# ADDENDUM

Project: **Arlington Woods Free Methodist Church Renovation**

**Addendum No.: A03**

Date: August 13, 2020

**ADD03.02**

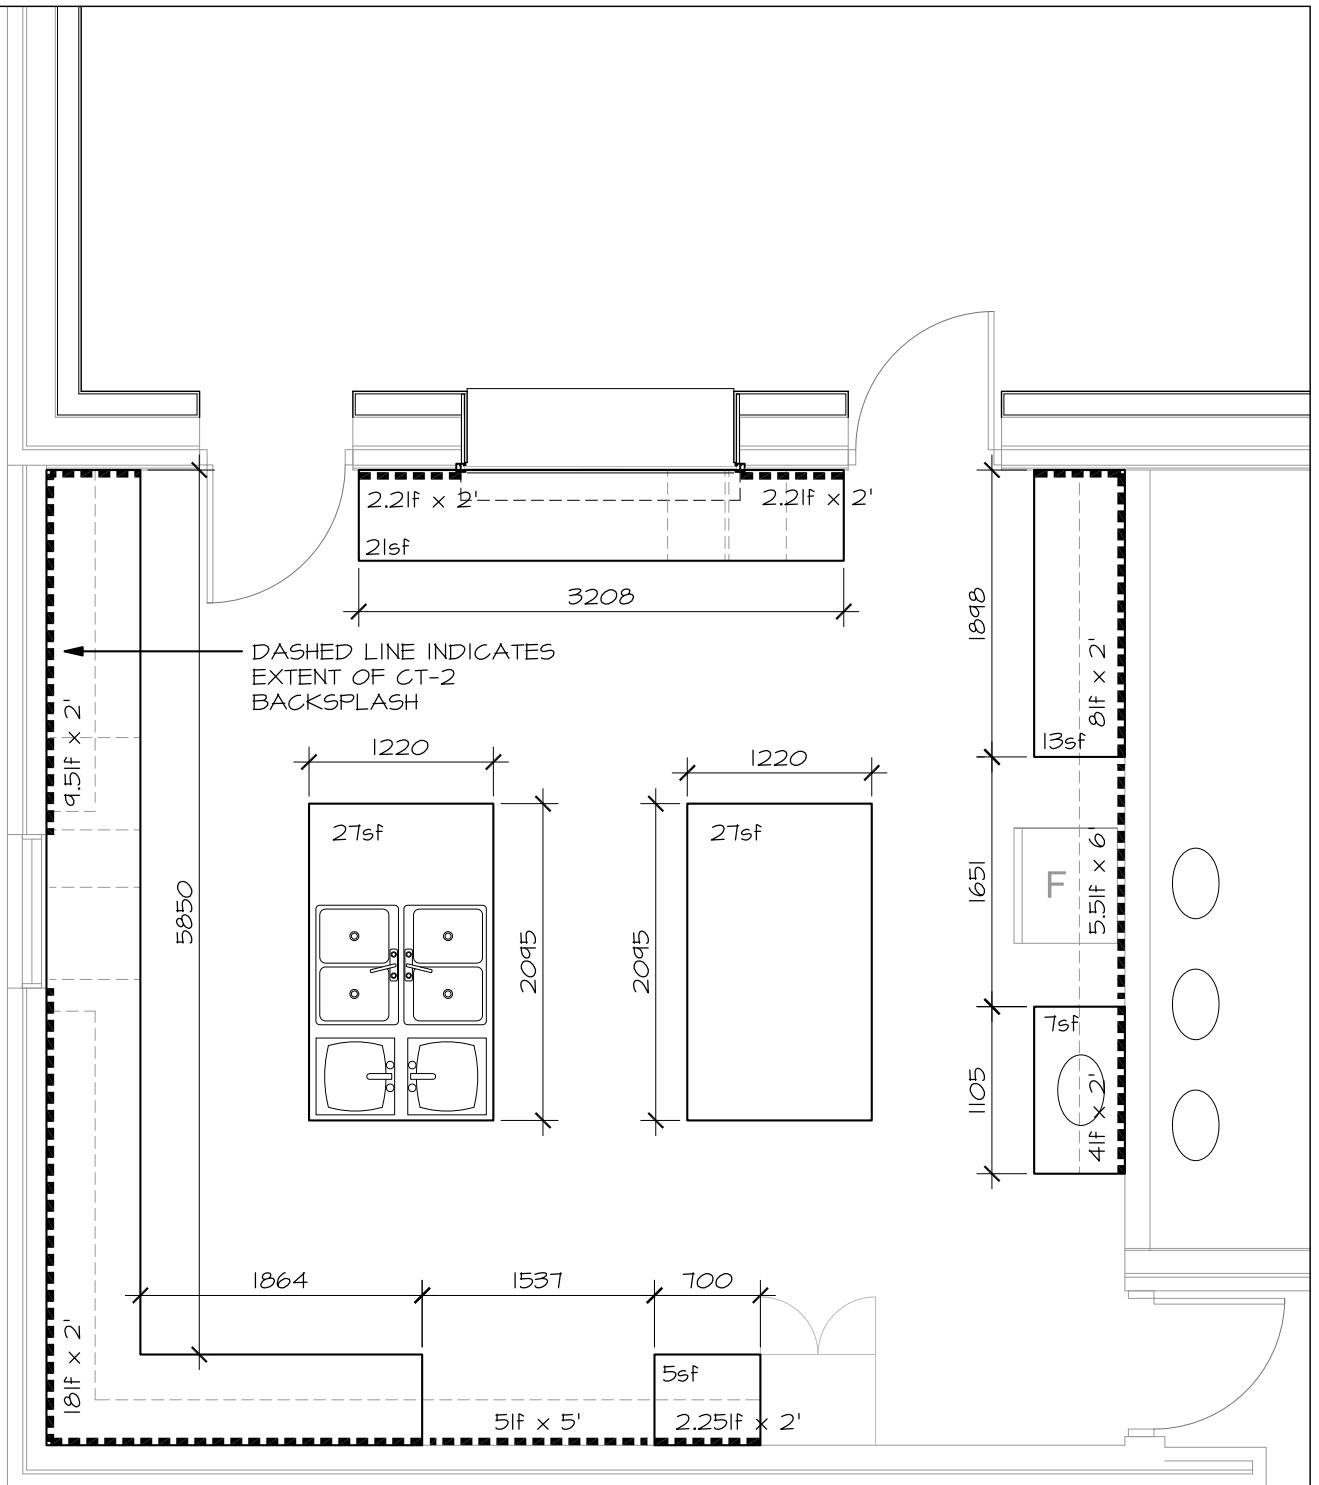
| <b>Item No.</b>     | <b>Drawing or Spec Section</b> | <b>Description</b>   |
|---------------------|--------------------------------|--|
| A3.1.4              |                                | <b><u>Kitchen 110:</u></b><br>Refer to the attached Architectural Sketch ADD-03.02 for extent of new CT-2 ceramic tile backsplash (3” x 6”) between existing upper & lower cabinets. Allow for 180sf of CT-2 tile. At Refrigerator location, CT-2 to extend from floor to underside of upper (approx. 6’). At oven locations, CT-2 to extend from floor to underside of uppers (approx. 5’). Interior Elevations to follow at issuance of Construction Drawings. |
| A3.1.5              |                                | <b><u>Kitchen 110 – Plan:</u></b><br>Refer to the attached Architectural Sketch ADD-03.02 for extent of p-lam removal and replacement to existing countertops and 100mm high p-lam backsplash. Carefully remove countertops for transportation to shop where removal of p-lam finish and replacement can occur. Refer to Section 06 47 00 for p-lam specifications.  |
